INDEPENDENT EXAMINATION OF THE STINSFORD NEIGHBOURHOOD PLAN

Questions to Stinsford Parish Council (SPC) and Dorset Council (DC)

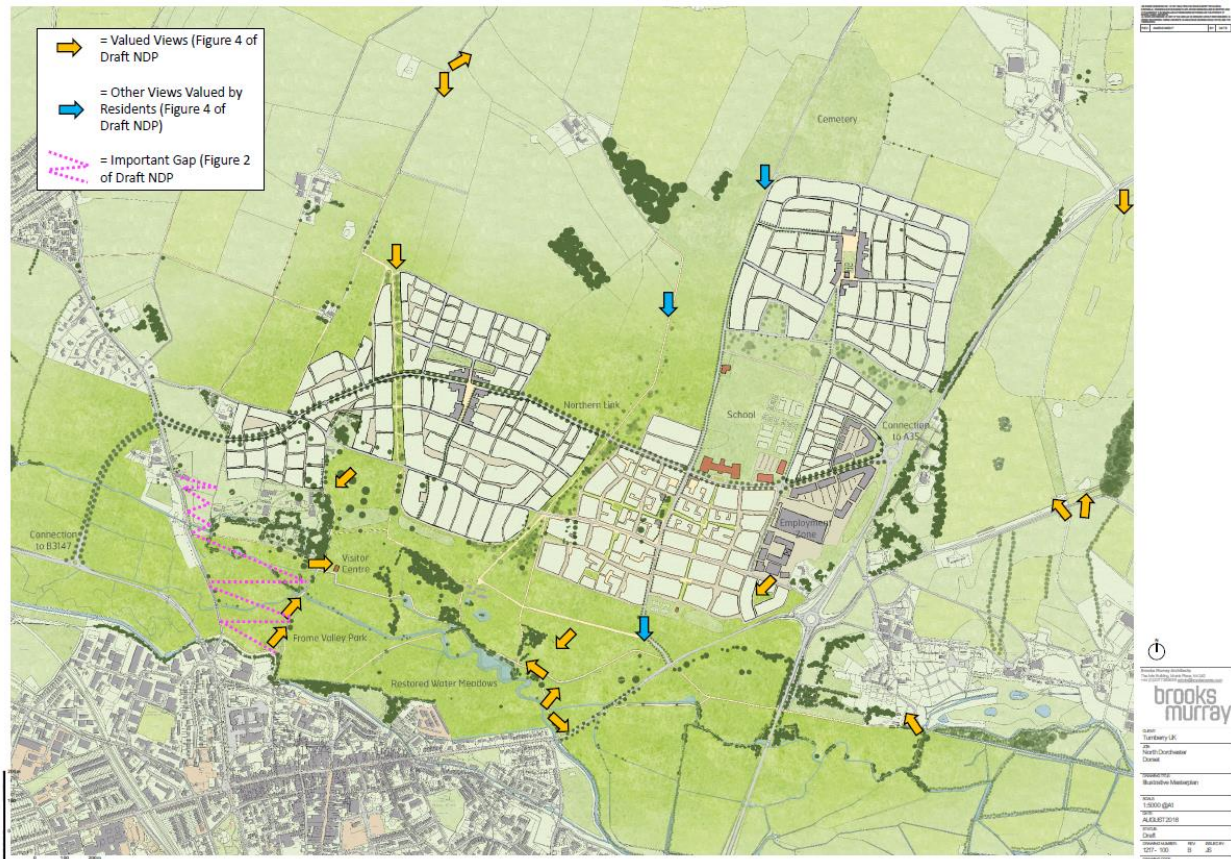
- a) Please could another Figure 4 be submitted which corrects the anomaly of the number of Valued Views on the map (which the key shows as 8) and the Important Local Views in Table 4 (of which there are 7), and which would include numbering the views on the map?
- b) In addition, please could the numbered Valued Views on Figure 2 be rationalised so that viewpoints located outside the Plan area on the edge of Dorchester are removed?

SPC –The number on the key of Figure 4 related purely to the direction rather than the view ‘number’

However in response to (b) please see separately attached Figure 4 (revised) which relates more closely to the proposed rationalised set of views. A more detailed description in Table 4 of the views shown would be as follows:

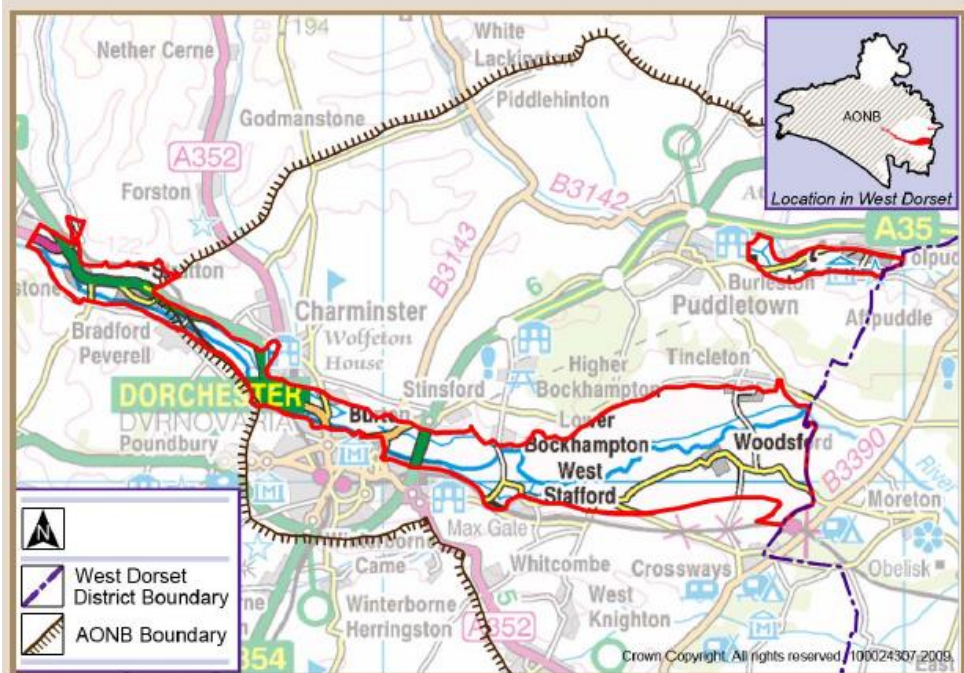
Whether there is sufficient evidence to underpin Policy SNP2 and SNP3

This comment was considered following Reg 14 (see Consultation Statement page 19). Dorset Council have not raised any issues in respect of Policy SNP2 and also support SNP3 in principle, although they do not consider it sufficient to define the River Valley Landscape' area as a 'valued landscape'. The suggested change to the wording of the final sentence of SNP3 by Dorset Council is acceptable, but SPC would also seek to make the case that it is a valued landscape in light of the following attributes:

The river valley area has been adjusted to follow field boundaries, taking into account that this makes more sense 'on the ground' and in terms of policy interpretation, particularly as the delineation does not follow any other recognisable factor such as a contour line or geological / soil changes.
